## EBERSPAECHER – PARKING EXPANSION JSP17-18

Consideration of the request of Nowak & Fraus Engineers on behalf of Eberspaecher America for Preliminary Site Plan and Stormwater Management Plan approval. The subject parcel is located in Section 12, west of Haggerty Road and south of Thirteen Mile Road. It is approximately 8.21 acres and zoned OST (Office Service Technology). The applicant is proposing an additional 66 parking spaces as part of reconfiguring the existing parking lot and converting existing vacant land to parking spaces.

# PLAN REVIEW CENTER REPORT

Eberspaecher - Parking Expansion  
**JSP17-18**

**SHEET**  
 Landscape Plan

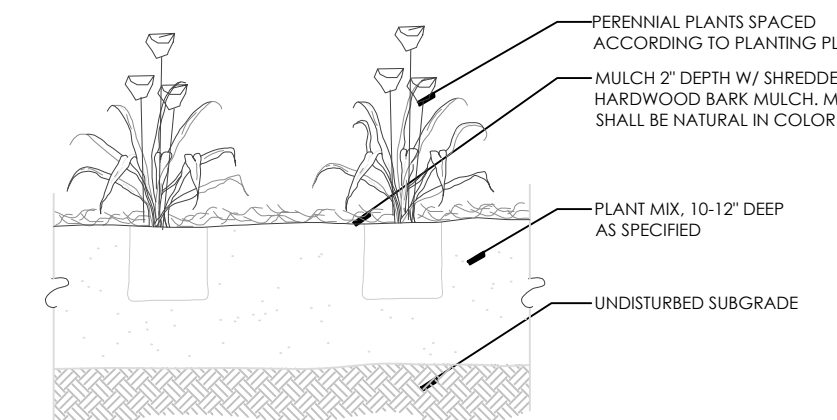
1. Based on the vehicular use areas, 1,892 sf of islands and 25 trees are required. 2,228 sf of islands and 8 trees are provided.
2. **Please add additional trees where possible, and without creating unhealthy growing conditions for new or existing trees, in the parking lot islands.**
3. **A Planning Commission landscape waiver must be requested for the parking lot trees that aren't provided.**
4. **The missing tree in the northern island of the existing parking lot should be replaced.**

1. No calculations are proposed. 5 of the proposed trees can count toward the perimeter requirement.
2. Please add calculations for parking lot perimeter trees required along the north, west and south sides of the proposed expansion.
3. **Please add trees around the periphery where possible, and without creating unhealthy growing conditions for trees. Trees should be spaced a minimum of 30 feet on center.**
4. **A Planning Commission landscape waiver must be requested for the parking lot trees that aren't provided.**

1. Only 57% of the basin has planted or naturally occurring landscaping along it. **Please add sufficient large native shrubs along the high water line of the pond to bring the coverage to 70-75%.**
2. **Please remove the Phragmites that has infiltrated the pond edges. This should be done in late summer/early fall by a licensed pesticide applicator.**

**The proposed landscaping must be provided with sufficient water to become established and survive over the long term. Please note how this will be accomplished if an irrigation plan is not provided.**

2. Calculations for the required parking lot perimeter trees along the north, west and south sides of the expansion shall be added. A total of 10 trees are required.
3. 10 perimeter trees shall be indicated to meet the requirements.
4. A waiver is not requested for the perimeter trees.

1. Proposed native shrubs shall be indicated around the detention pond to bring coverage to 70-75%.
2. A note shall be added to remove the Phragmites in the detention pond in late summer/early fall by a licensed pesticide applicator.

1. An automatic irrigation system will be proposed to be extended from the irrigation existing system, to be presented on an irrigation plan.
